## PinePhone 1.2 VCONN Hardware Fix

This page details a hardware fix for an issue that was found on early PinePhone hardware revisions (see [PinePhone#Hardware revisions](#) for an overview of the different revisions) and has been fixed since the 1.2a hardware revision.

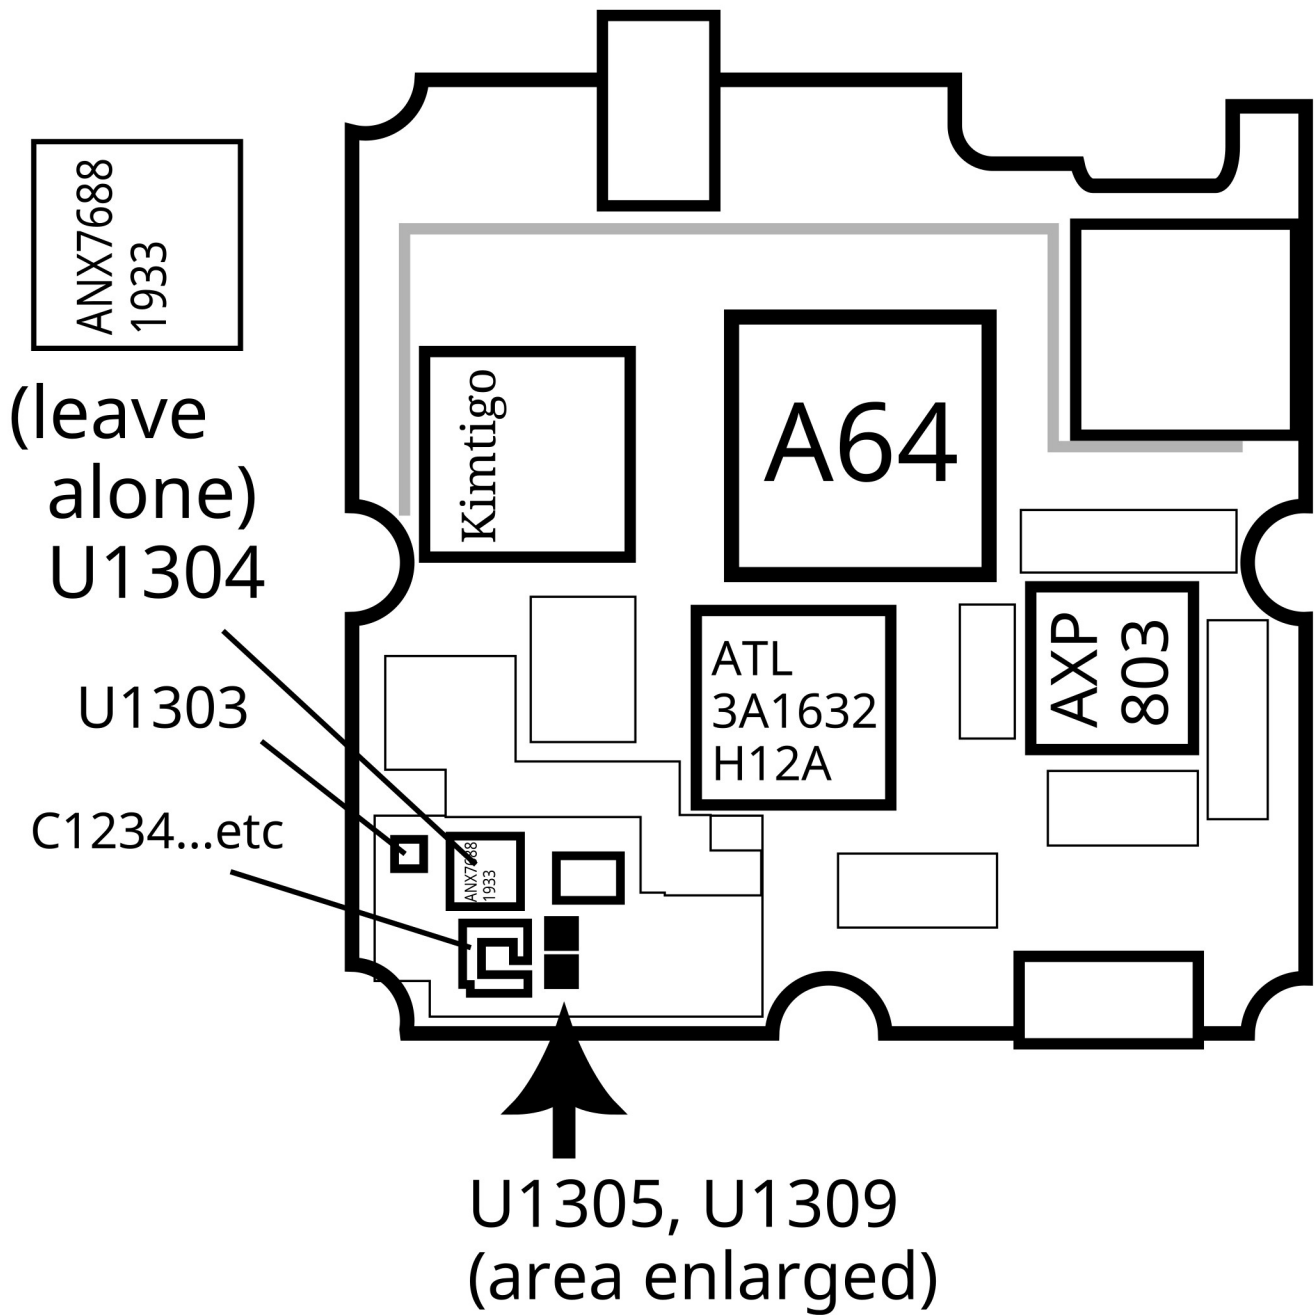
The issue arises due to the switches that were chosen up to v1.2a (the a revision excluded) of the PCB assembly: the infamous AW3512, labelled U1305 and U1309 on the schematic. Instead of leaving the output pin "dangling" with a high impedance when disabled, the switch pull the output down. This feature is intended for discharging a capacitor, hence its "Quick output discharge" name. This is an excerpt from the datasheet:

This issue prevents cable plug/orientation detection and USB-PD communication. ANX always sees cable as plugged even if none is plugged. There's no SW workaround for automatic detection of cable plug or power role.

HW fix is to replace AW3512 with a variant of the chip that preserves the EN signal polarity and that doesn't have the "quick discharge function" that ties the output to the GND via a 75 Ohm resistor when the switch is OFF. mozzwald used NCP334FCT2G as a replacement. PCBA revision 1.2a onwards incorporate that fix.

U1305, U1309

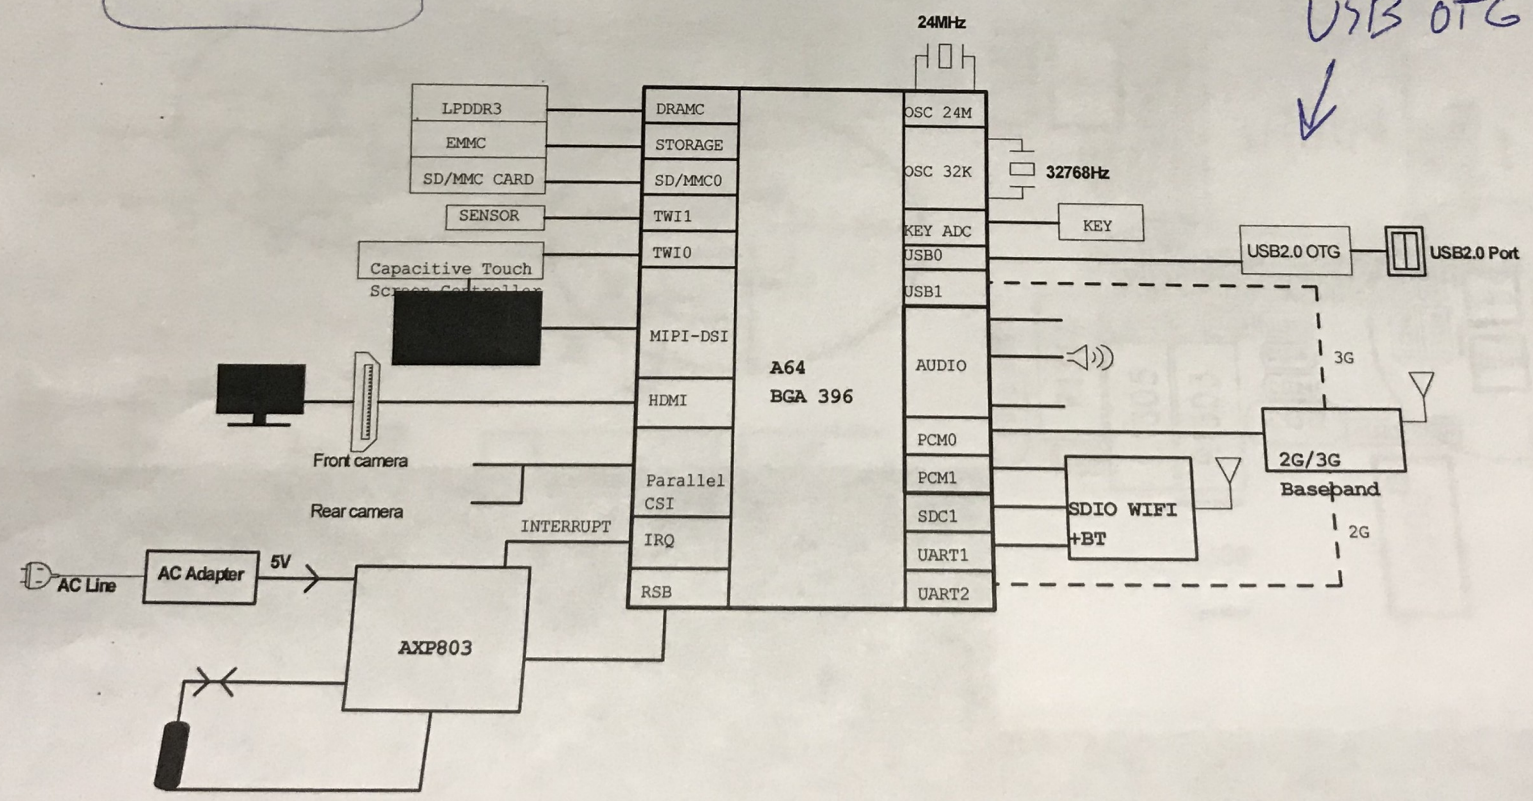
- careful of other components
- carefully remove + heat U1305, U1309
- careful not to short things around/below

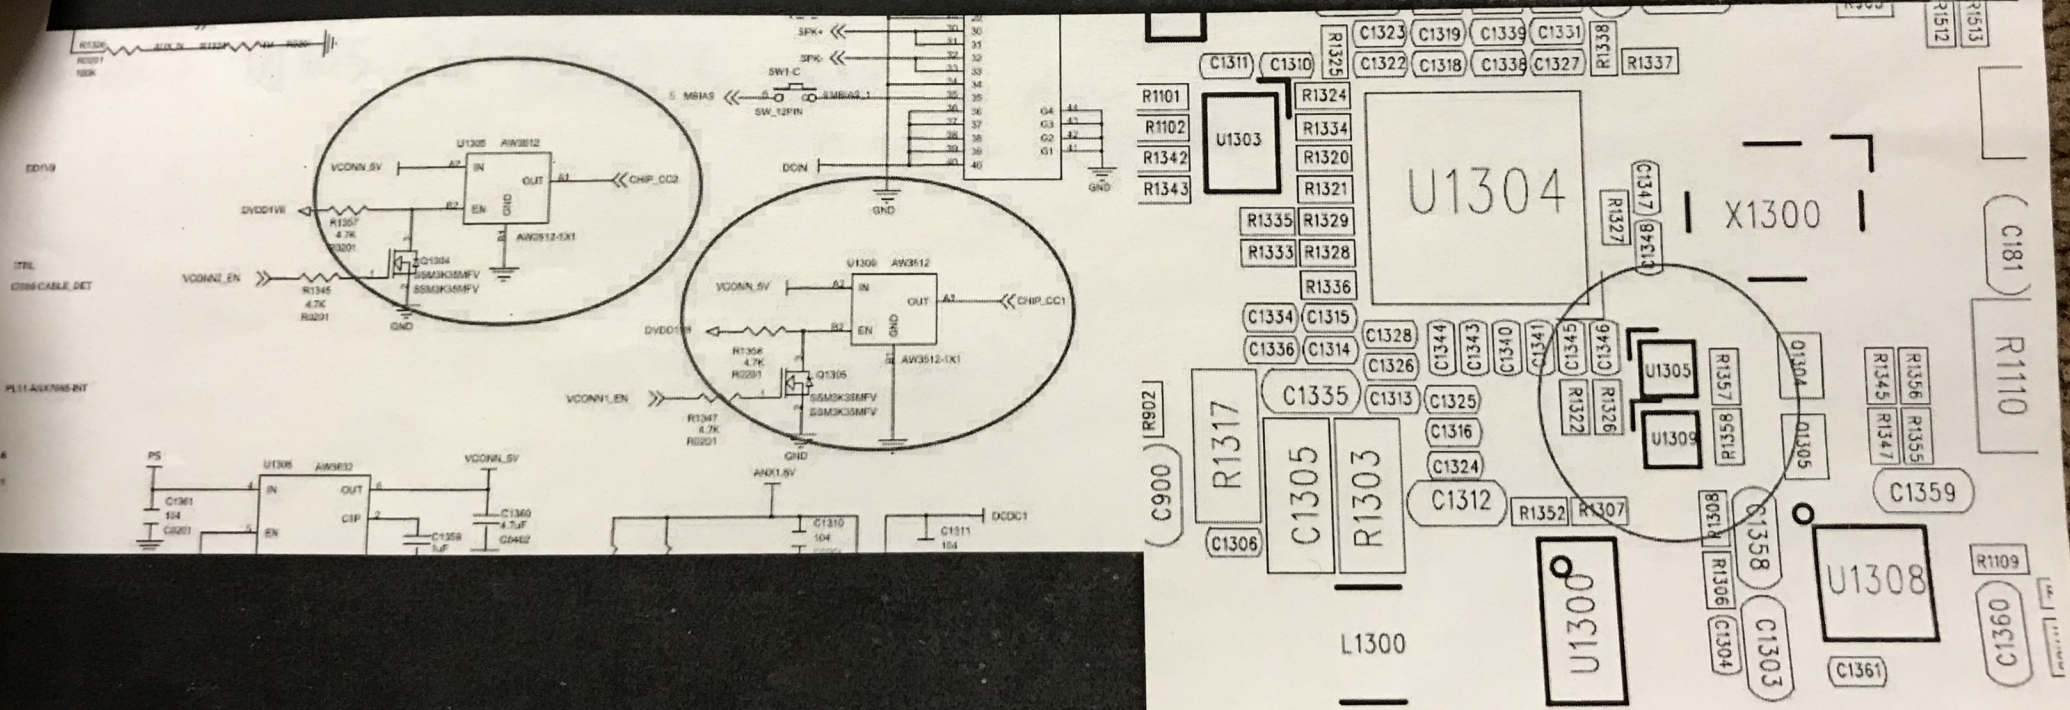
To fix USB-C CC pins, we need to desolder VCONN switches that are tying the CC pins to the ground when they're off, p from functioning correctly.

Desolder U1305 and U1309 to release CC pins  
which are always grounded

U1309

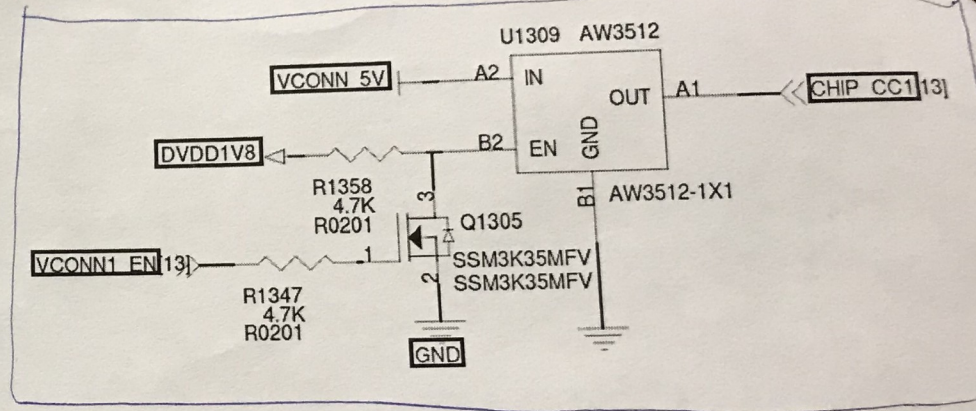
AW3512 switches
